Re - New Musuem Building.

New Museum Building

Re - Museum in Burns Garden.

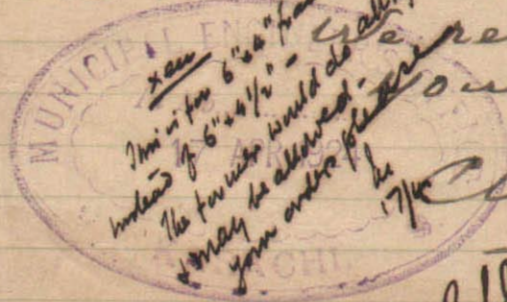
Re: the size of the door
+ window frames, our friends
have just written regretting
that their arrangements have
unfortunately been completed
already, & that it is now
too late to alter the sections
of the scanning.

Xerox
 This is for 6" x 6" from
 a 6" x 4 1/2" - 4 1/2" remain
 would do
 moved -
 yours faithfully

Reference to their letter dated 16th April 1924, Messrs Charry & Coy., are informed that 6" x 4" frames for the door & windows will do.

SKETCH OF DOORS & WINDOWS FOR MUSEUM BUILDING.

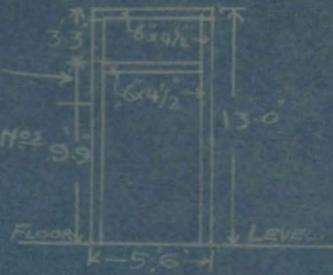
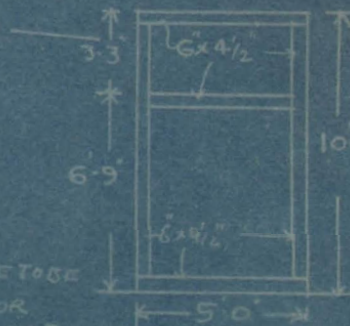
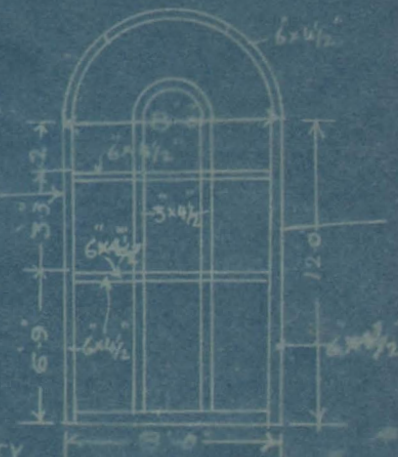
Messrs Cheary & Co are directed to prepare
the P-T frames of Doors & Windows as per attached
sketch the detail of Shutter will be follow

3/4" GROOVE TO BE
PROVIDED FOR
SHUTTERS ON BOTH SIDES.
